ATTACHMENT B
Unsafe Structure Determination
Letter and Report

RE: Block 40, Great Southern Hotel
1830 Young Circle, Hollywood, Florida 33020

REPORT OF FINDINGS

GREAT SOUTHERN HOTEL
1830 YOUNG CIRCLE
HOLLYWOOD, FLORIDA
FOLIO NO.: 5142-15-01-7810

13. Typical view of the third level tie beam with cracked, spalled and honeycombed concrete and exposed corroded reinforcement at the north area of the structure.

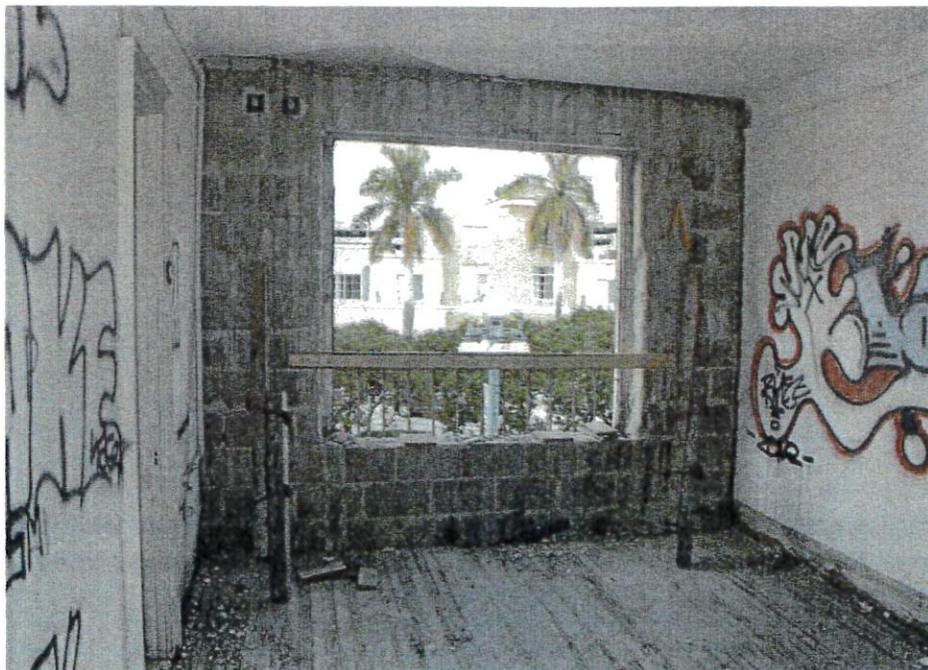
- Third level tie beam with cracked, spalled and honeycombed concrete and exposed corroded reinforcement at the north area of the structure (See photograph 13 & 14).

14. Typical view of the third level tie beam with cracked, spalled and honeycombed concrete and exposed corroded reinforcement at the north area of the structure.

Column w/excessive spalling (W façade)

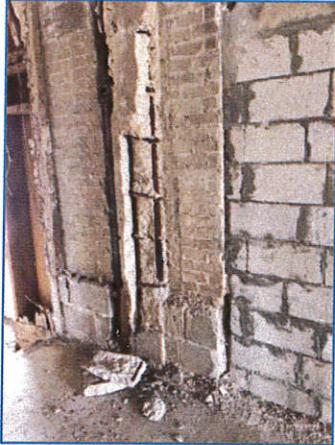
From the Building Department perspective, both the EOR and the Shoring engineer shall provide without delay written directives containing an evaluation of the structural integrity of the existing structure (in its current condition, during the partial demolition and the future construction phases). Specific instructions shall be given by the EOR and the Shoring Engineer regarding the structural stability of the existing building throughout the demolition and construction phases of the work, and to undertake all necessary precautions in order to assure safe construction activities within the building.

At this moment, no work shall be conducted in the existing building until such time as the evaluation and directives are provided and approved by the City of Hollywood Building Department/ CAP Government, Inc.
